Subject: Rear Chassis Electrical Harness attachments replacement upfit interface

Models Chevrolet Silverado, GMC Sierra 3100

Affected: Series HD Cab Chassis models only

Origination Date: February 13, 2020

Figure 1

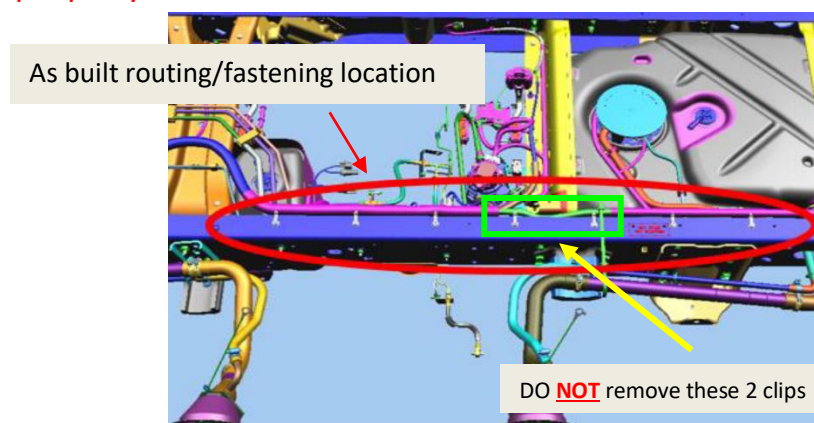
Some Chevrolet Silverado, GMC Sierra 3600 Series Cab Chassis upfits may require alternative rear chassis harness attachments. Wiring Harness `Service Access` could be compromised when mounting an upfit body. Upfit Body mounting provisions could lock in the OEM harness/attachments.

Upfit body mounting practices should allow for service of chassis wiring harness/attachments. For upfits that utilize semi-continuous `top of frame rail` contact, it is recommended that the rear electrical harness attachments be replaced with alternative `service accessible` components. The following will provide instructions for replacement of the OEM rear harness attachments if it is deemed necessary refer to figure 1.

- 1) Remove with wiring snips, **6** of the 8 factory black plastic harness clips in areas shown (see Fig. 1) **IMPORTANT:** Do **NOT** remove the 2 factory plastic attachment clips (green area) located by the rear fuel tank lines.
- 2) Replace removed attachments with (6) new metal hoop clips & low-profile plastic push-pins as shown in Figures 2 & 3. Use recommended GM Service or OEM supplier parts listed below.
- 3) Check rear harness routing, make sure new attachments are securely fastened and harness is not chaffing chassis fuel components. Upfit body/equipment can now be installed.
